**PLANNING APPROVAL &  
PLANNED UNIT DEVELOPMENT****Date: September 20, 2007****NAME**

McGill-Toolen High School (Fr. Bry Shields)

Planning Approval to amend the previously approved Comprehensive Master Plan for an existing school in an R-1, Single-Family Residential district to allow its expansion to include existing parking and entrance drive reconfigurations, a covered walkway between across-street sites, new science classroom buildings, a new student center, and a new classroom building, and Planned Unit Development Approval to amend a previously approved Planned Unit Development Approval to allow multiple buildings on a single building site.

This site plan illustrates existing and proposed buildings with off-site parking.

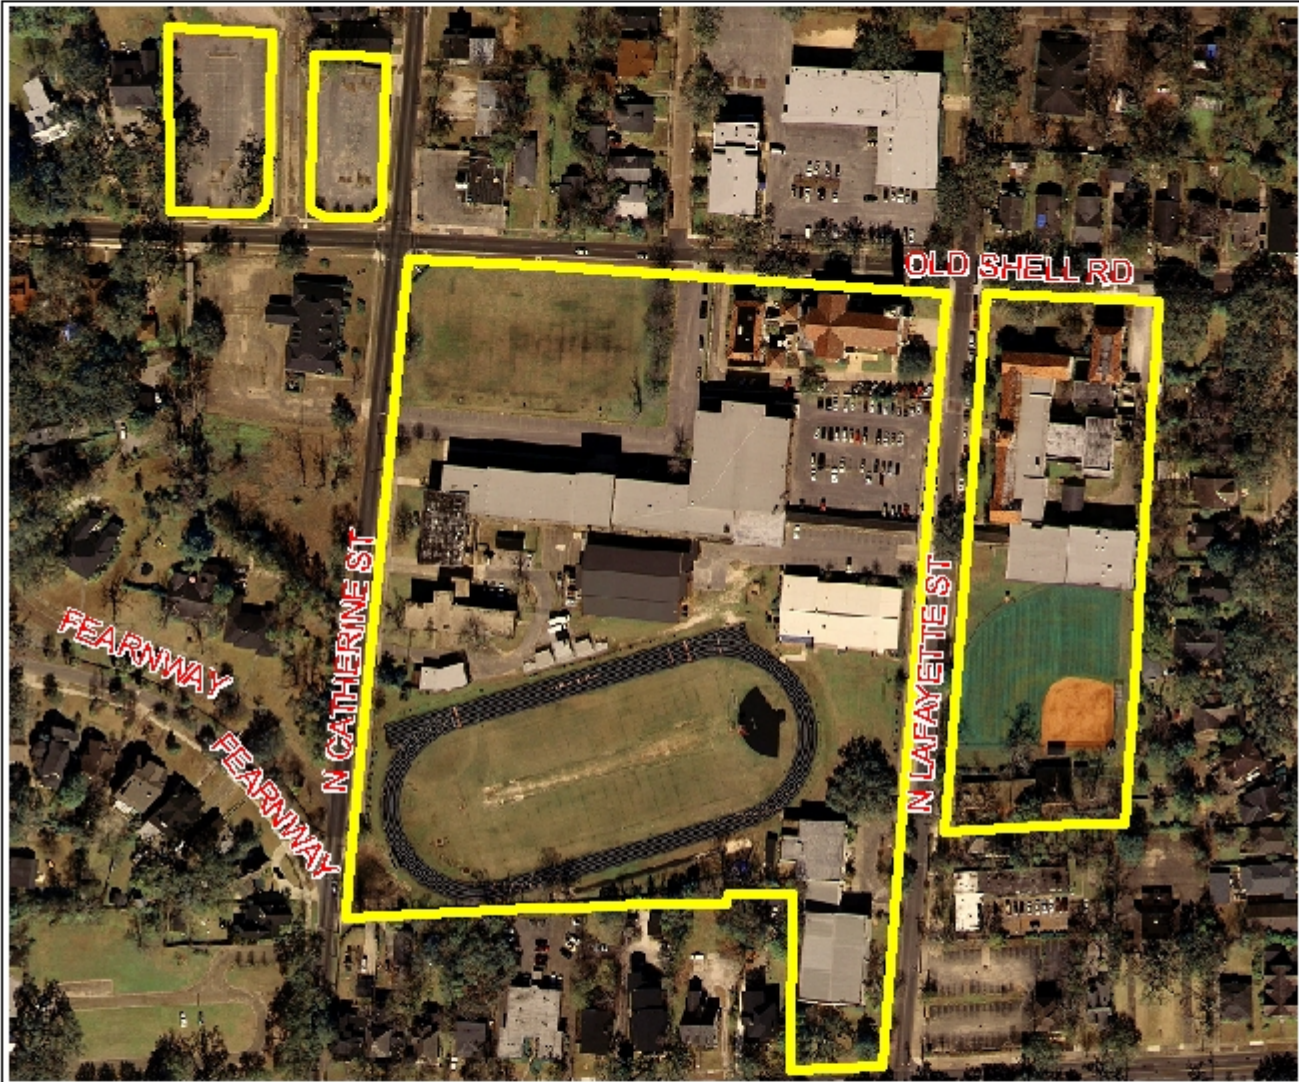
The site plan depicts the existing and new paved parking area layout that will change with the proposed construction of the Science building and the Student Center. However, the overall site plan does not illustrate the number of on-site parking spaces available to the parking ratio of one space per four students. It should be noted with the addition of the Student Center (-105 spaces) and the addition of the parking lot (+30) along North Catherine Street; therefore, the site will lose 75 parking spaces. Additionally, the site plan reflects 48, 90 degree spaces within the right-of-way of North Catherine Street, which would not be allowed per comments by Traffic Engineering, a site plan for Planning approval and Planned Unit Development (PUD) submitted in 2005 illustrates 20, 60 degree spaces along North Catherine Street. Therefore, only the illustrated 20 angled parking would be allowed, since the new parking would not comply with today's standards.

The site plan also shows extensive landscaping and trees within the science building project area; however, it does not illustrate existing landscaping and trees as well as the buffering requirements of the Zoning Ordinance.

The site plan illustrates an about street level cross over of Lafayette Street to provide a student access to the Toolen building. However, the applicant has not submitted elevation dimensions to allow approval of this phase.

Finally, there is no indication on the site plan as to the proposed location of any dumpster or other waste storage facility. If the applicant utilizes a dumpster, the location of the storage area for the dumpster must be indicated on the site plan, and the location and required screening must comply with Section 64-4.D.9. of the Zoning Ordinance, as well as with all other applicable regulations.

*A primary concern of the applications related to the expansion of the school is the relationship with the surrounding area. The initial submissions did not illustrate the overall campus; to be specific; the application did not include the additional parking to the Northeast and Southwest. Another issue was the parking within the right-of-way along South Catherine Street and Lafayette Street, which seems to be increased.*

*As mentioned in the previous reasons for holdover, the site plan should illustrate existing landscaping and trees; however, compliance with the landscaping and tree requirements would only be required within the project area since the campus is significantly treed. It should be noted that these applications mention a Phase II; however, no details of this Phase are included in the submission. Therefore, submission of Planned Unit Development (PUD) and Planning Approval application should be required for Phase II.*

- 1) the revision of the Planning Approval site plan to include all parking areas that are used by the students and staff and reflect the change in parking spaces and reduction of landscaping with plan detail regarding the connection of the proposed parking facility with existing parking facilities so that staff can determine if existing parking and circulation facilities will be impacted;*
- 2) the illustration of sidewalks or the submission of a sidewalk waiver;*
- 3) a revised site plan depicting compliance with the tree and landscaping requirements of Section 64-4.E. of the Zoning Ordinance for the project area; and*
- 4) the approval of the design and location of existing parking spaces along North Catherine Street within the right-of-way by Traffic Engineering.*

- 1) the revision of the Planned Unit Development (PUD) site plan to include all parking areas that are used by the students and staff and reflect the change in parking spaces and reduction of landscaping with plan detail regarding the connection of the proposed parking facility with existing parking facilities so that staff can determine if existing parking and circulation facilities will be impacted;*

- 2) the construction be limited to the submitted and approved site plan for Phase I;*
- 3) the provision of landscaping, trees and buffering where the site abuts residential uses;*

- 4) revision of the site plan to depict the existing sidewalks all road frontages;*
- 5) revision of the site plan to depict any dumpster storage facility, in compliance with Section 64-4.D.9. of the Zoning Ordinance;*

- 6) placement of a note on the site plan stating that on-site lighting must fully comply with Sections 64-4.A.2. and 64-6.A.3.c. of the Zoning Ordinance; and*
